# UNITED STATES PATENT AND TRADEMARK OFFICE

APPLICATION NO.	FILING DATE	FIRST NAMED INVENTOR	ATTORNEY DOCKET NO.	CONFIRMATION NO.
10/045,541	10/26/2001	Gerald N. King	0267-001-1436CON	3566

<b>Office Action Summary</b>	Application No. <b>10/045,541</b>	Applicant(s) <b>King</b>	
	Examiner <b>Son Nguyen</b>	Art Unit <b>2839</b>

## **DETAILED ACTION**

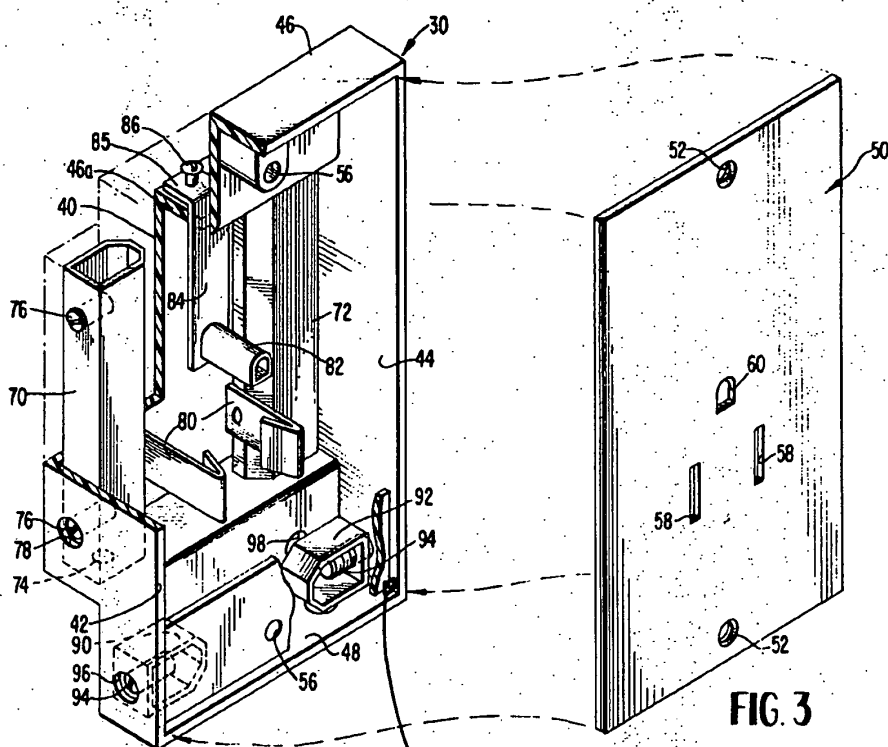
- the base unit [30, figure 1] having a receiving channel [not labeled, see attachment], and a bottom of the removable electrical device [36, figure 1] adapted to nestle within the receiving channel of the base unit.

Applicant argues that the art of record neither discloses nor suggests the structure of a removable electrical device adapted to nestle within a receiving channel of a base unit in combination with a base unit having a channel for receiving an electrical device. Examiner respectfully disagrees. Castellano discloses a base unit [30, figure 1] having a receiving channel [not labeled, see attachment], and a removable electrical device [36, figure 1] adapted to nestle within the receiving channel of the base unit, as applicant newly claimed.

a receiving channel for holding a bottom of a removable electrical device.
